DCA Runway 19 Chartered Visual Pre/Post Dec. 10

Date: December 10, 2015

RIVER VISUAL RWY 19

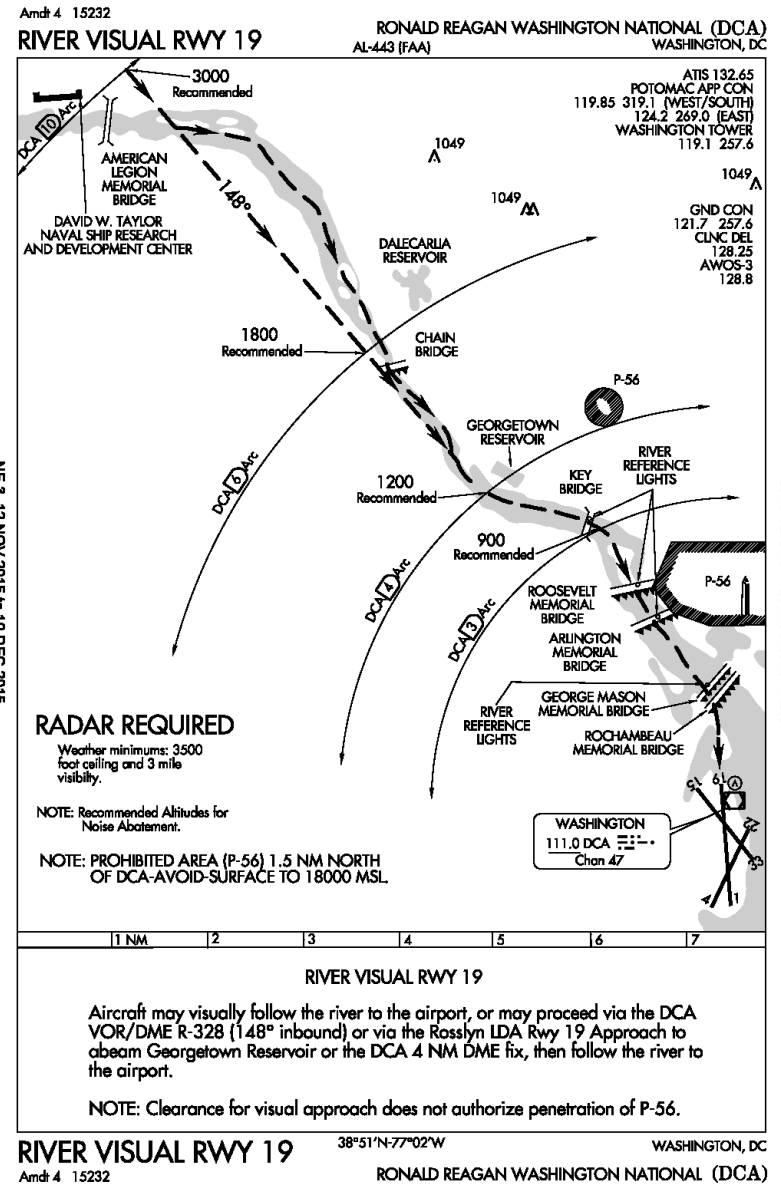
- 1) Aircraft may visually follow the river to the airport.
- 2) Aircraft may proceed via the 148 radial inbound to the DCA VOR/DME
- 3) Aircraft may fly the LDA Y RWY 19 approach to a point abeam the Georgetown Reservoir OR the DCA 4 NM DME fix

- 1) Aircraft may visually follow the river to the airport or...
- 2) **NEW:** Aircraft may proceed via the RNAV (RNP) RWY 19 approach to SETOC then follow the river to the airport

Note: Option to fly the 148 radial inbound to the DCA VOR/DME and the option to fly the LDA Y are both removed.

NOTE: Recommended altitude abeam the Georgetown Reservoir increased from 1200 feet to 1500 feet.
